Calais at Pelican Bay

Project Management Report 21 – Building F

RE: Post-June 2nd Meeting Update – Unit F-303, F-304, F-305 Post-Tension Cable Investigation and Repair Strategy

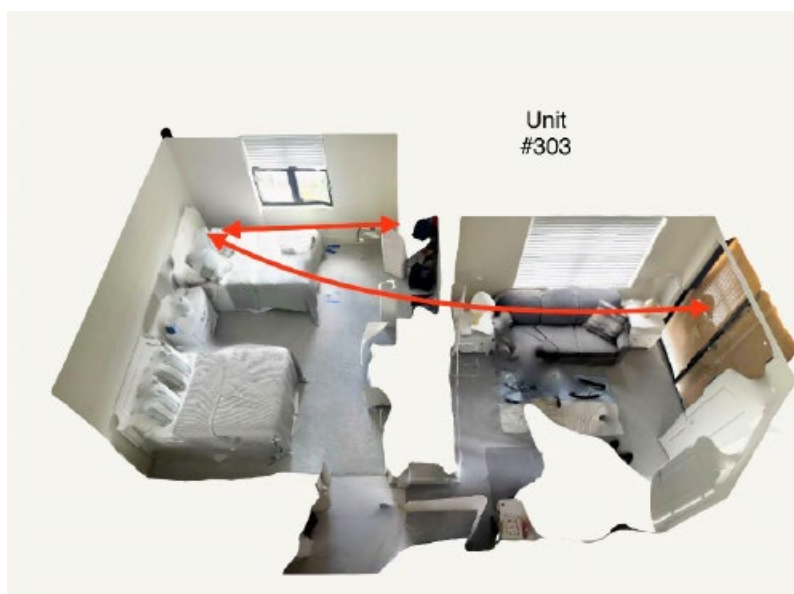
Unit F-305 condition: damage observed at balcony slab edge. Cable observed with wedges released.

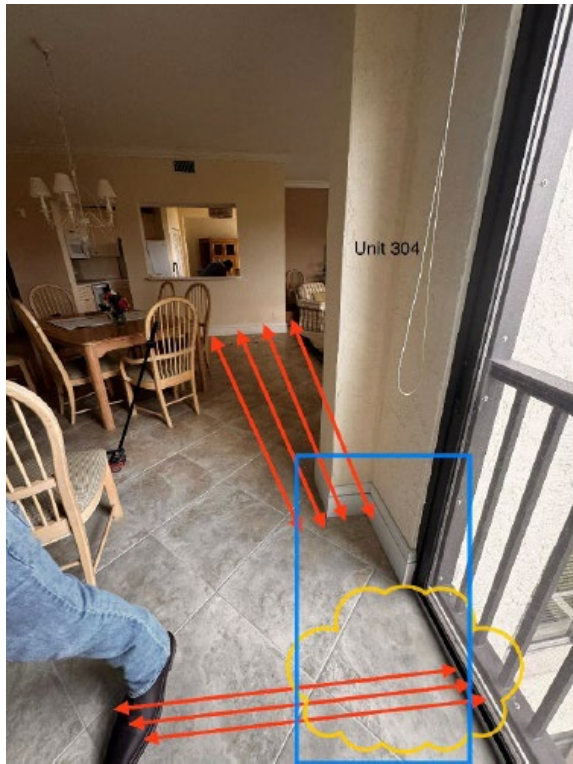
Building Plans discrepancy: GPR scan confirmed path of the tendon groups emanating from Unit F-303 balcony slab edge to Unit F-305 balcony slab edge. Blue highlighted area indicated heavy concrete saturation in GPR scan in direct path of band line and uniform cable tendons.

Unit F-303: confirmed path of tendons and new group of band line cables confirmed starting at the exterior wall of the guest bedroom.

Unit F-304: confirmed path of tendons, yellow highlighted area reflected heavy saturation, blue highlighted area is the suspected area of consideration for possible tendon transition or break point.

Unit F-305: confirmed path of tendons through to the balcony slab edge.
